R66-series Lead-Acid Battery Installation Upgrade Kit Instructions

KI-262-1 for installation on R66 helicopters S/N 0003 thru 0519;

(To comply with R66 Service Bulletin SB-28)

FIGURE 1 Existing installation
(A780 cables with fuse holders shown)

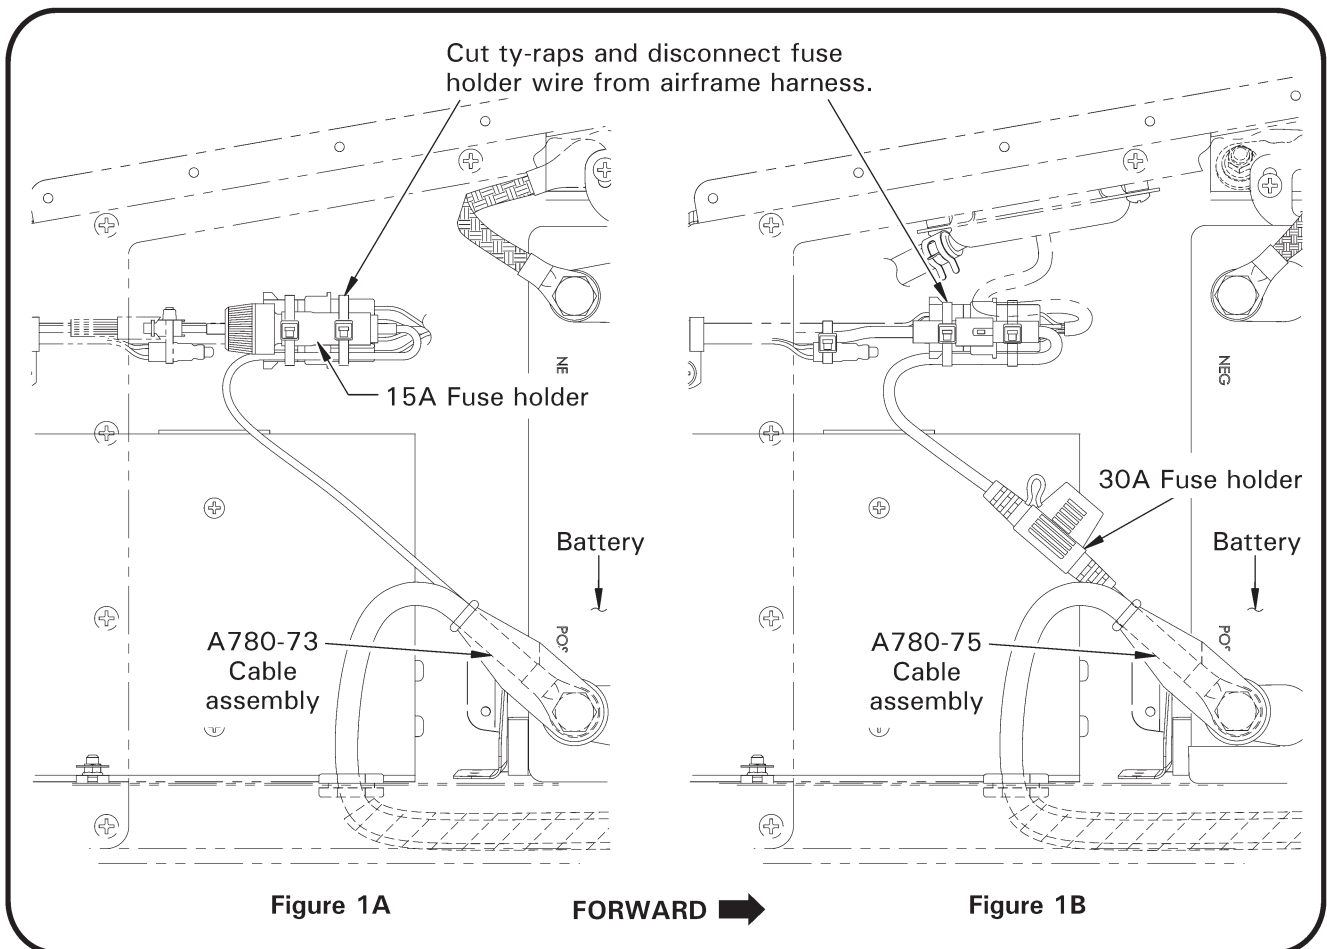
3. Refer to Figure 1. Locate fuse holder inside battery compartment, if installed. Cut ty-raps securing 15A fuse holder wiring (Figure 1A), or 30A fuse holder wiring (Figure 1B) to airframe harness. Disconnect fuse holder from airframe harness connector.

FIGURE 2 Early R66 helicopters (S/N 0062 & prior)

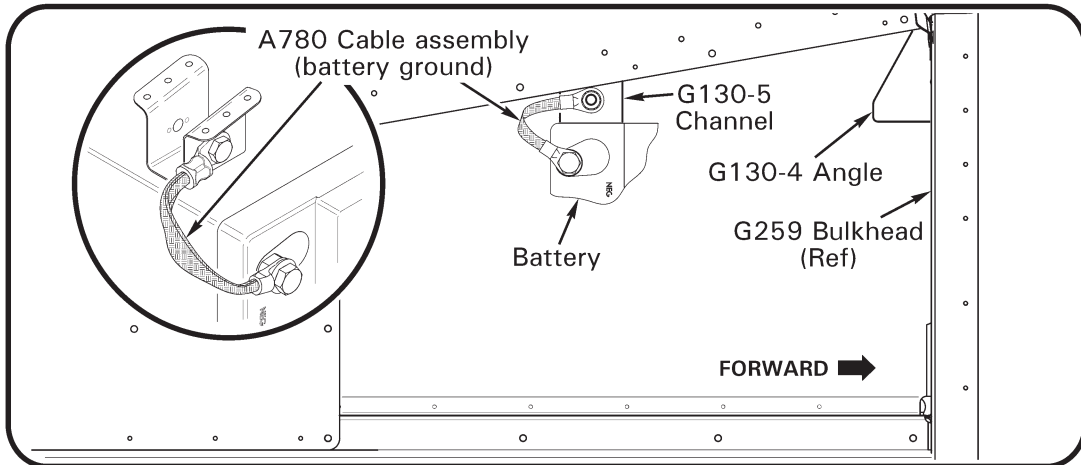
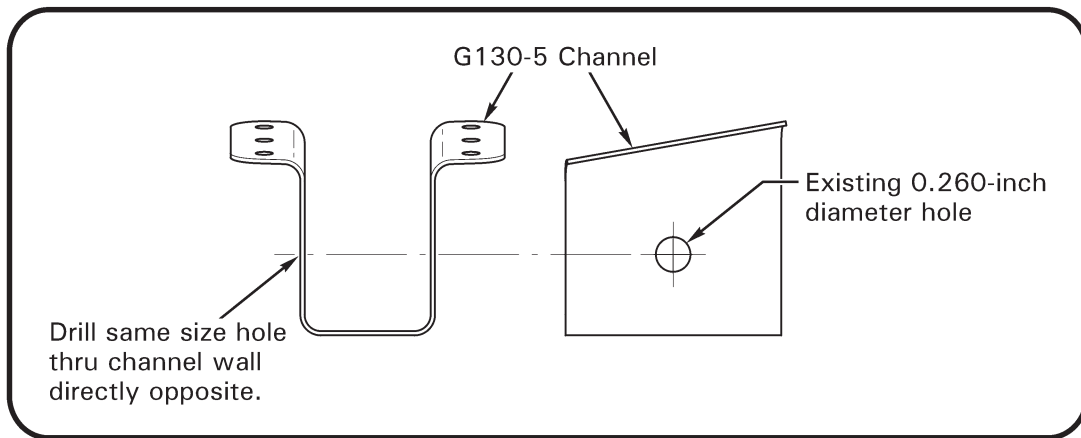
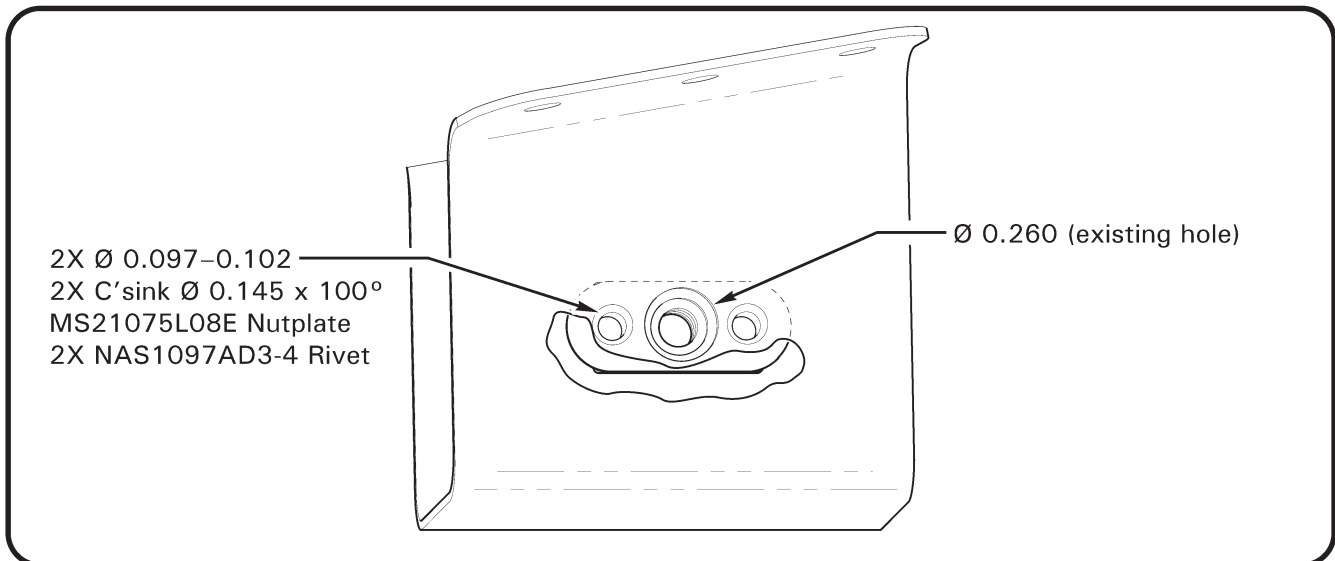
5. Refer to Figure 2, top. If battery ground cable is secured to (helicopter) inboard-side of G130-5 channel:
 - a. Remove and retain hardware securing ground cable to channel. Remove cable.

- b. Refer to Figure 2, center. Using appropriately-sized drill bit and newly vacated hole as guide, drill same size hole in channel wall directly opposite. Deburr hole.

- c. Remove paint from around newly drill hole (outboard-side) to promote conductivity. Clean up debris.
 - d. Temporarily attach MS21075L08E nutplate, centered over vacated inboard hole. Using scribe, trace rivet hole locations. Remove nutplate.

- e. Refer to Figure 2, bottom. Drill two 0.097 – 0.102-inch diameter rivet holes at marked locations. Deburr holes and on near-side, create 0.145 inch diameter, 100° countersinks. Clean up debris.

- f. Position nutplate on far-side and secure using (2) NAS1097AD3-4 rivets.

FIGURE 3 Layout location for new G130-4 Angle
(with nutplate installed, provided in kit as p/n KI-262-1A)

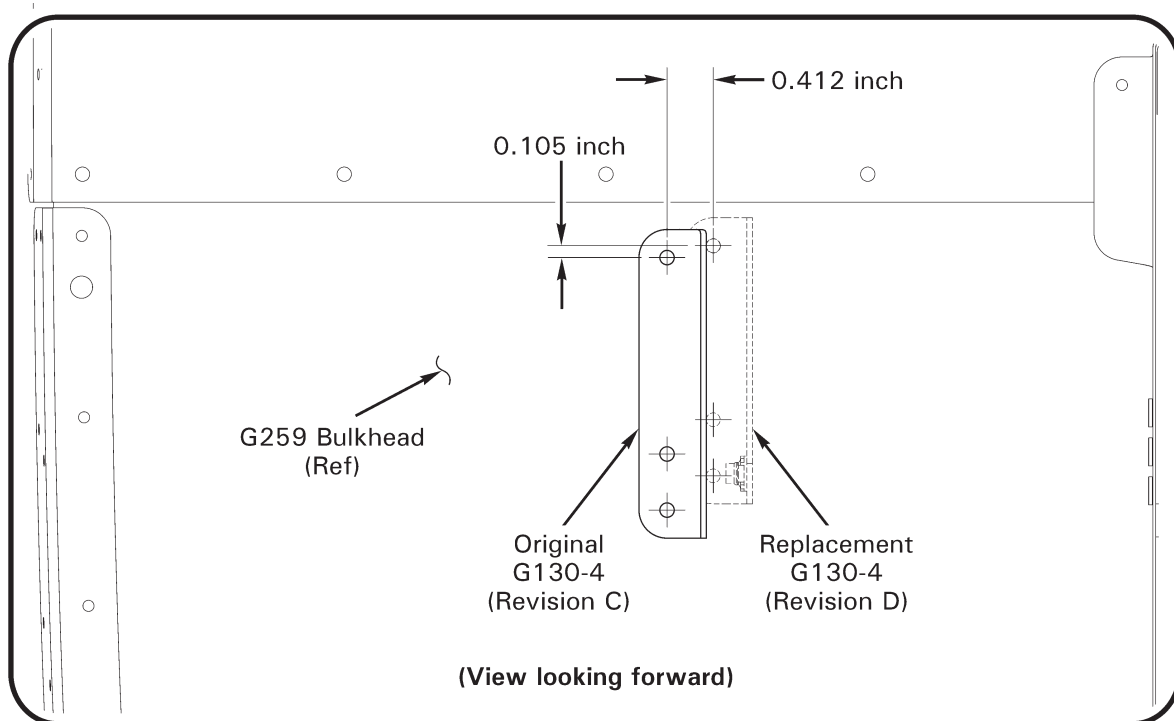
6. Remove aft-left seat back assembly (ref. R66 Illustrated Parts Catalog [IPC] Figure 25-1).
7. Refer to Figure 2, top. If G130-4 angle does not have a nutplate:
 - a. Drill out rivets securing G130-4 angle to G259 bulkhead. Remove and discard angle.
 - b. Refer to Figure 3. Layout top hole location for new G130-4 angle (with nutplate installed, provided in kit as p/n KI-262-1A) as shown. Drill one 0.130 inch diameter hole at location marked. Deburr hole.
 - c. Temporarily secure new G130-4 angle to bulkhead in newly-drilled hole, using appropriately-sized cleco.
 - d. With angle positioned vertically, drill two 0.130 inch diameter holes using G130-4 angle as template. Remove angle. Deburr holes and clean up debris.
 - e. Install new G130-4 angle using (3) MS20470AD4-4 rivets.

FIGURE 4 Replacement A780 battery power cable assemblies

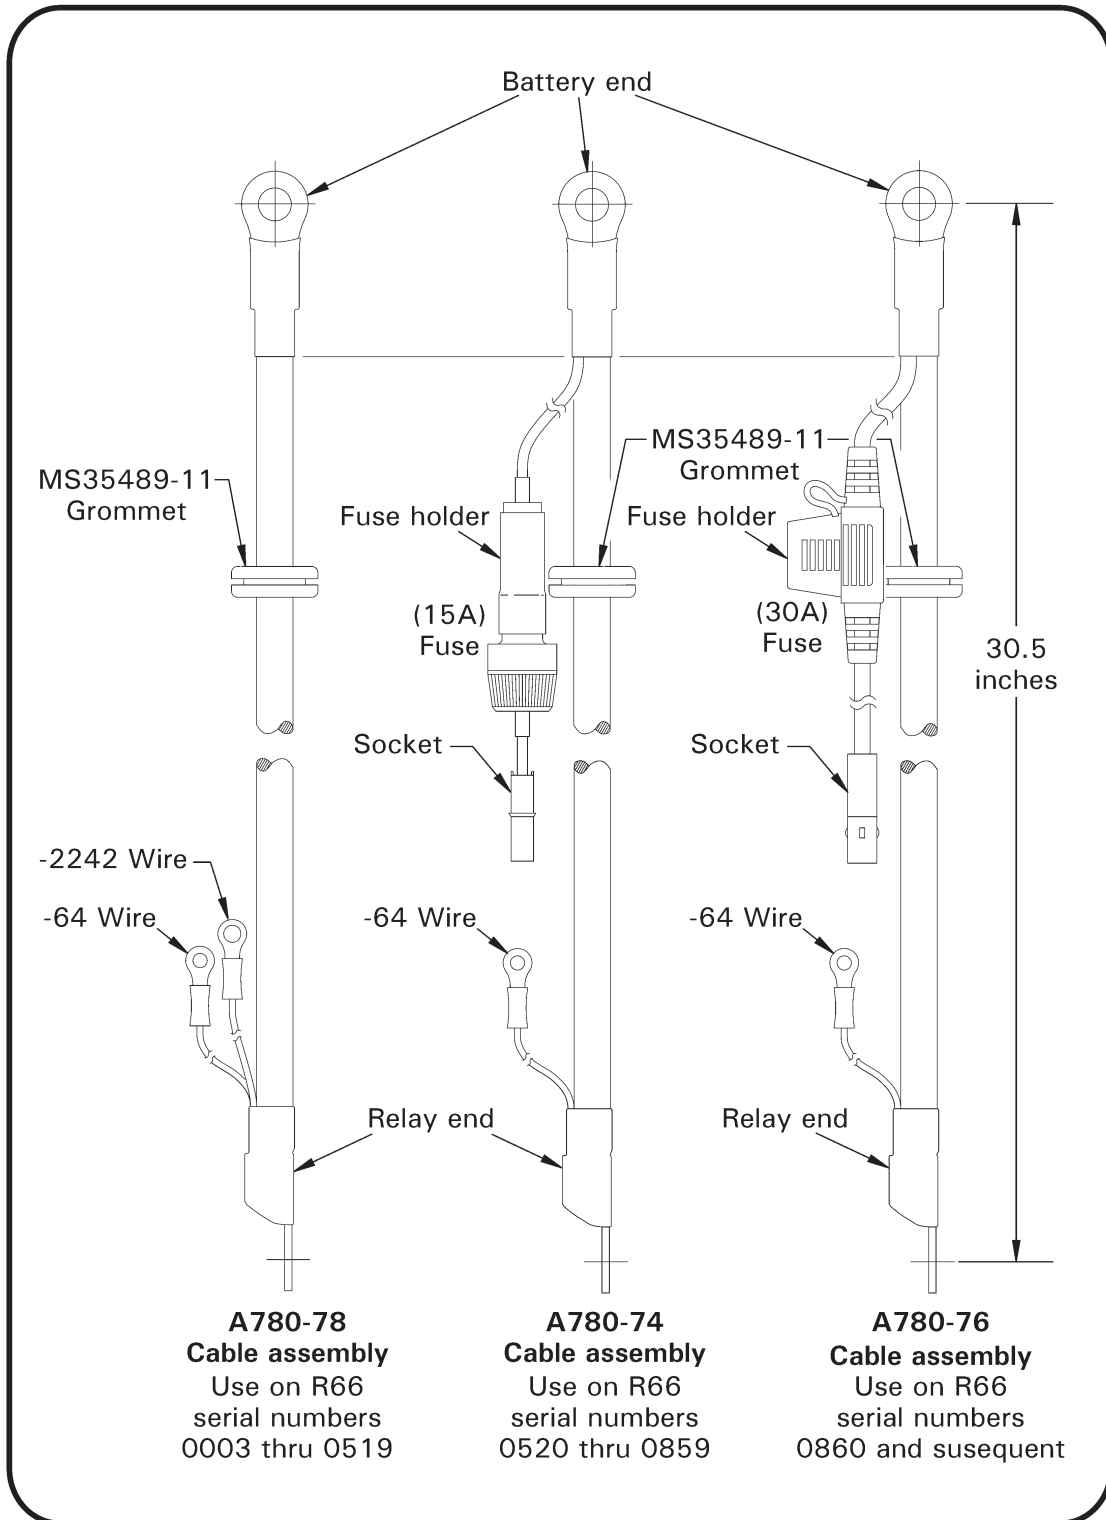
9. Remove A780 battery power cable, spirap, and two MS35489-11 grommets (one at each end) from helicopter and discard.
10. Refer to Figure 4. Position (1) MS35489-11 grommet on battery-end of new A780-74, -76, or -78 cable assembly, as appropriate to helicopter serial number. Grommet must seat on cable only and not on fuse holder wiring.

FIGURE 5 B237-7 battery revised installation shown

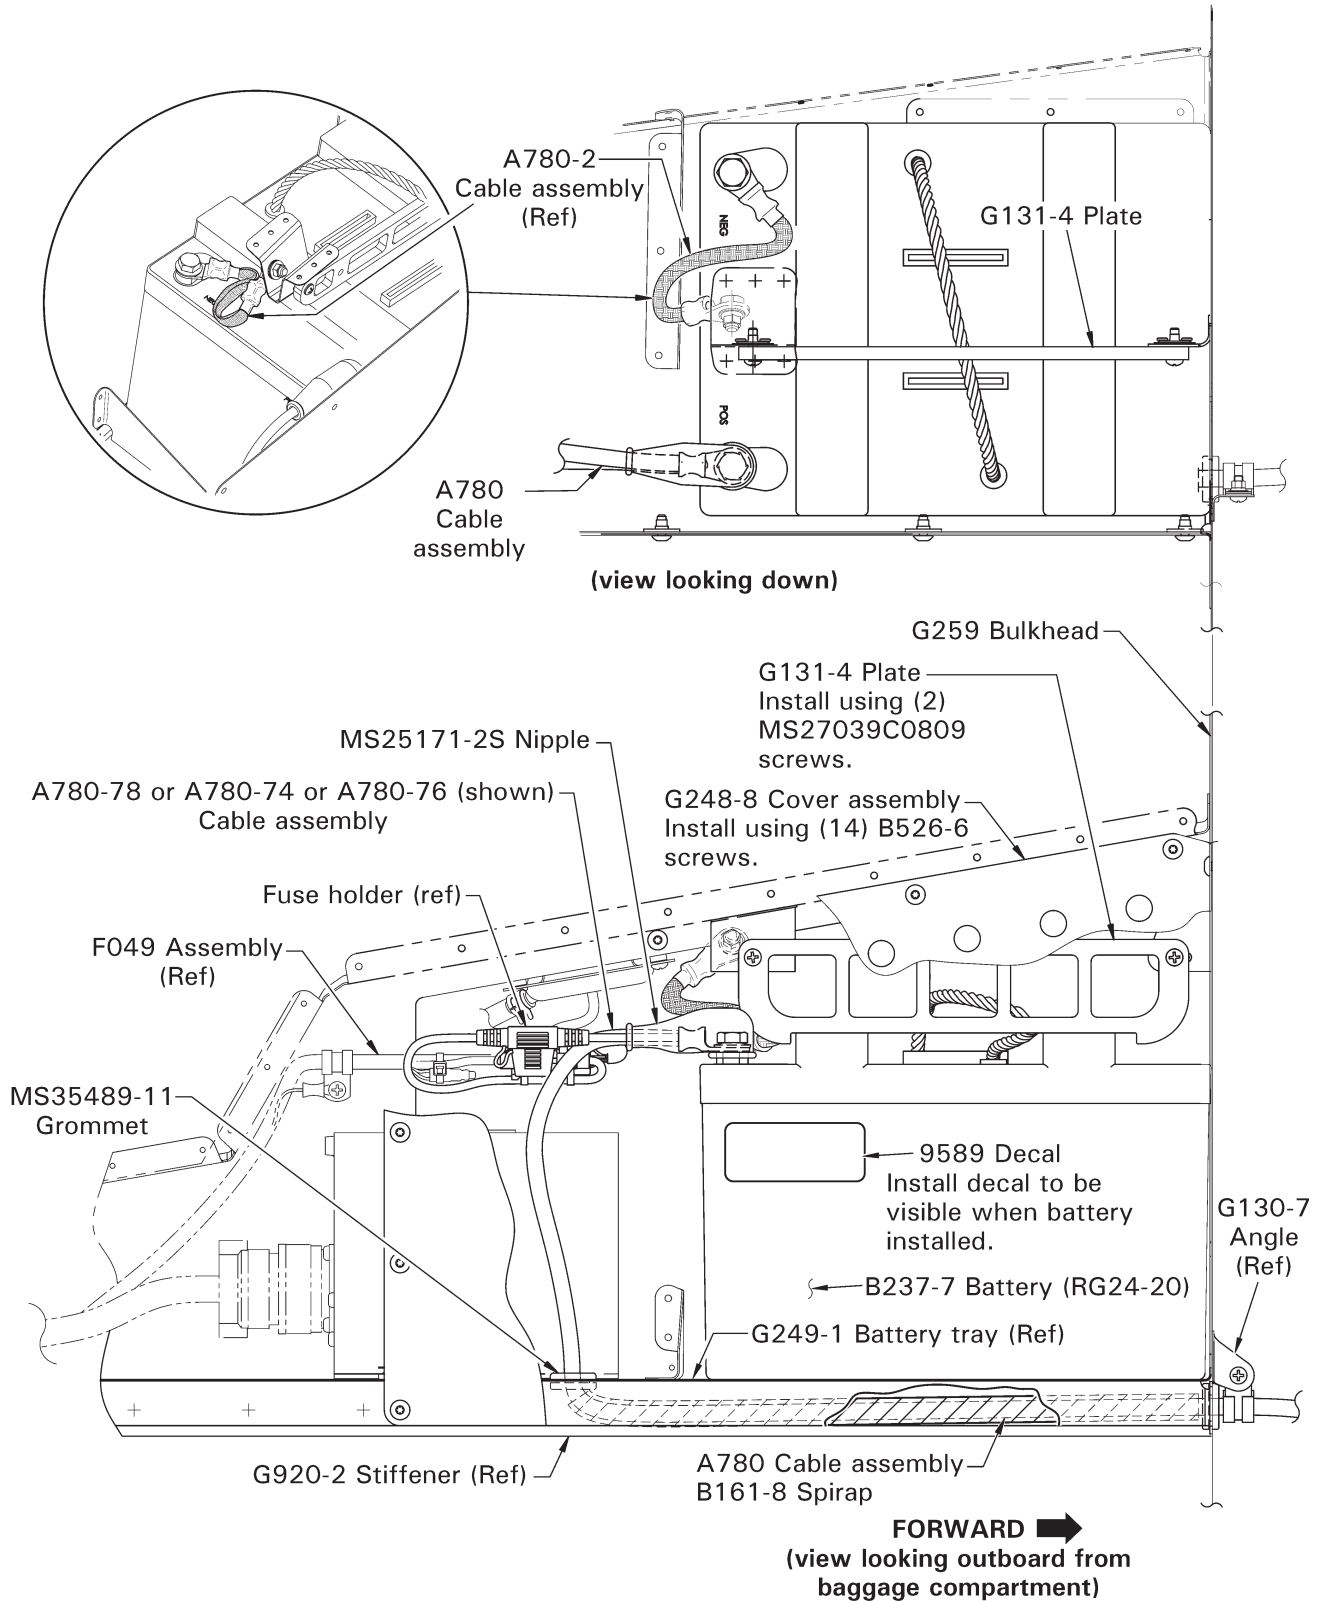
11. Refer to Figure 5 (B237-7 battery) or Figure 6 (B237-8 battery), as applicable. Feed relay-end of cable thru hole in G249-1 battery tray and forward thru G920 stiffener toward G259 bulkhead. Pull cable thru bulkhead hole from forward-side, using needle nose pliers or similar tool. Adjust protruding length according to measurement recorded in Step 6 NOTE.

15. Refer to Figure 5 or 6, as applicable. Install 9589 decal on battery as indicated, unless previously installed in location shown. Verify battery terminal surfaces are clean to ensure electrical conductivity.
For B237-8 battery: Refer to Figure 6. Install G131-5 terminal assembly (position as shown) to negative (ground) battery terminal with battery hardware. Special torque battery terminal bolt as noted on battery label and torque stripe per MM Figure 5-1.

16. Verify A780-2 ground cable is positioned as shown in Figure 5 or 6 where it is fastened to the airframe. If required, loosen installation hardware securing A780-2 cable to airframe and position cable assembly terminal aft as shown in Figure 5 or 6. Secure terminal hardware and standard torque per MM 20-30.

**FIGURE 7 Installation of A780 cable assembly with fuse holder
(Aft-left seat back removed)**

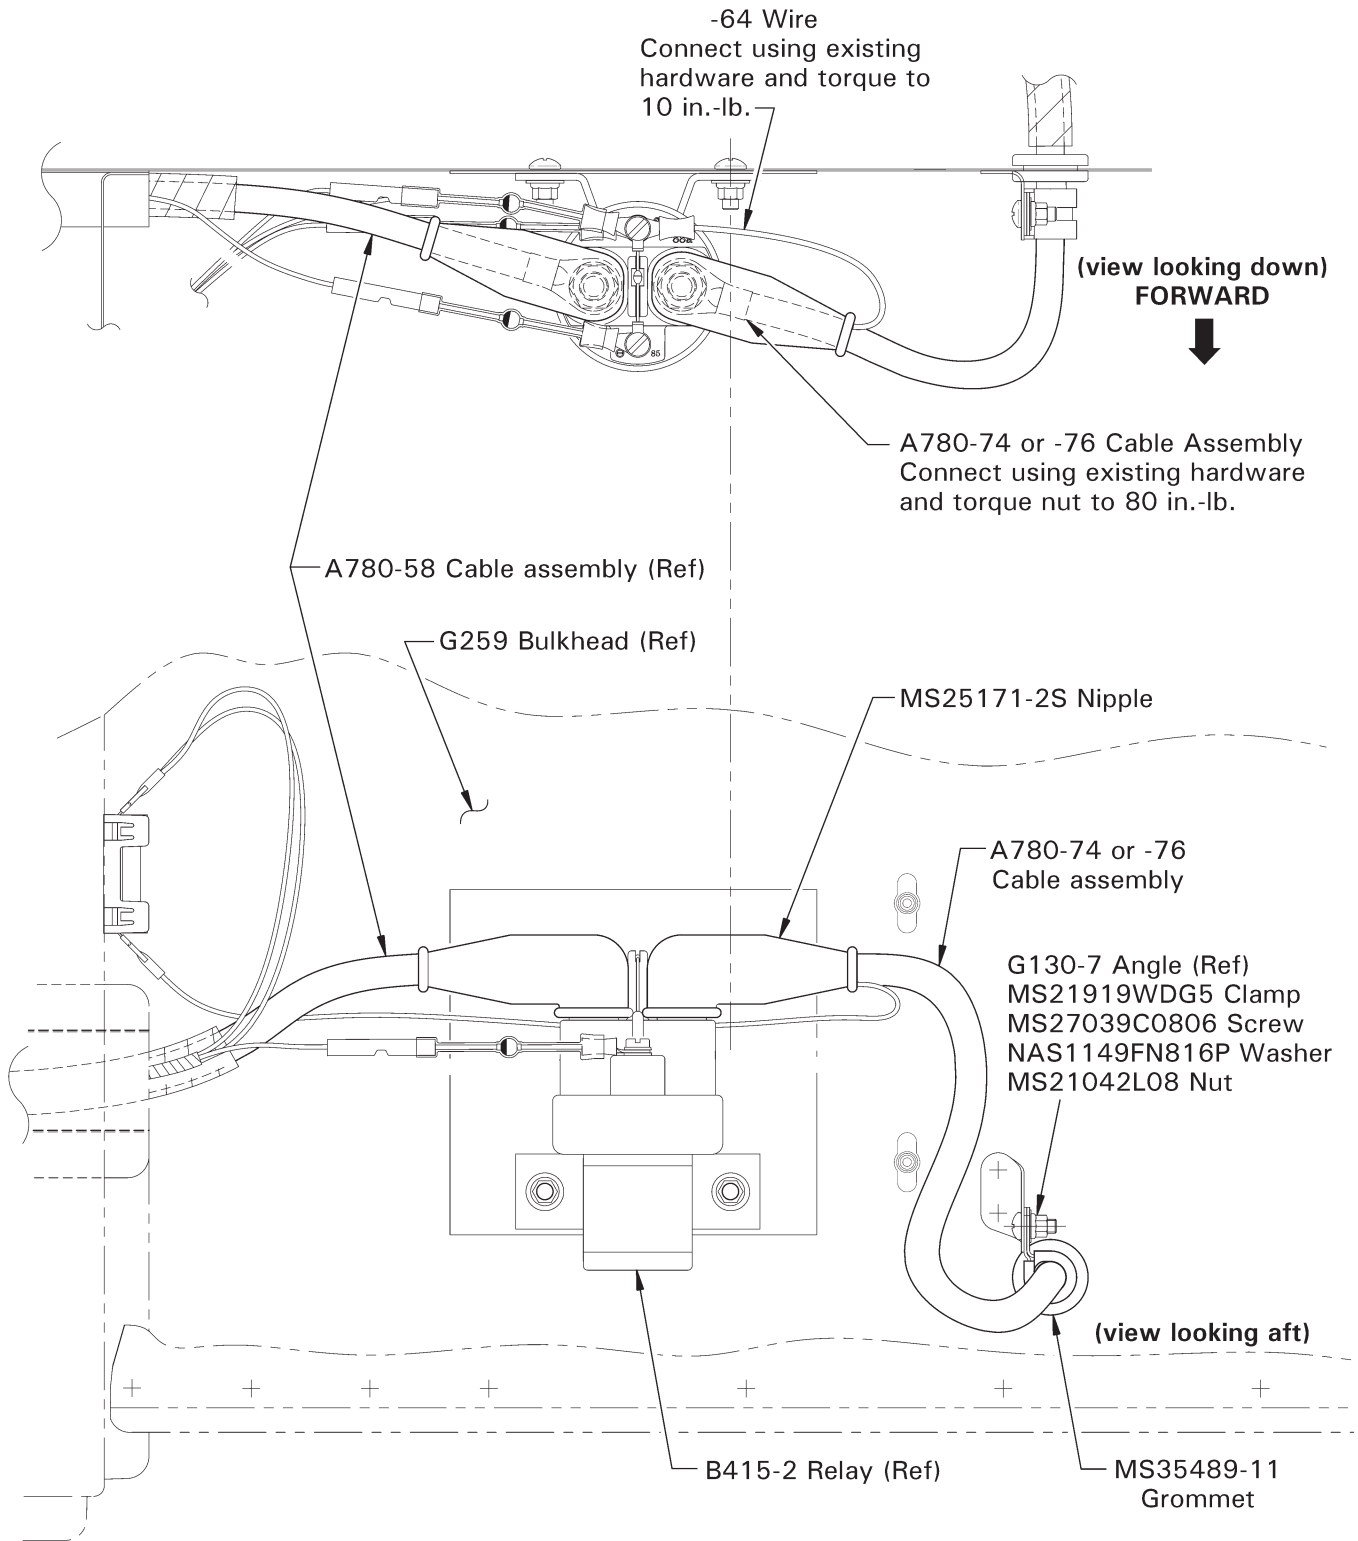
13. Refer to Figure 7 or 8, as applicable. Position MS25171-2S nipple onto relay end of replacement cable. Connect A780 cable to battery relay outboard stud and special torque nut to 80 in.-lb; verify security. Torque stripe per MM Figure 5-1 and position nipple over stud. Connect cable's -64 wire to relay terminal "86 +" and special torque screw to 10 in.-lb; verify security. **For A780-78 cable:** see Figure 8. Connect cable's -2242 wire to rectifier; verify security.

14. Refer to Figure 7. Secure A780 cable to G130-7 angle using (1) MS21919WDG5 clamp, (1) MS27039C0806 screw, (1) NAS1149FN816P washer, and (1) MS21042L08 nut.
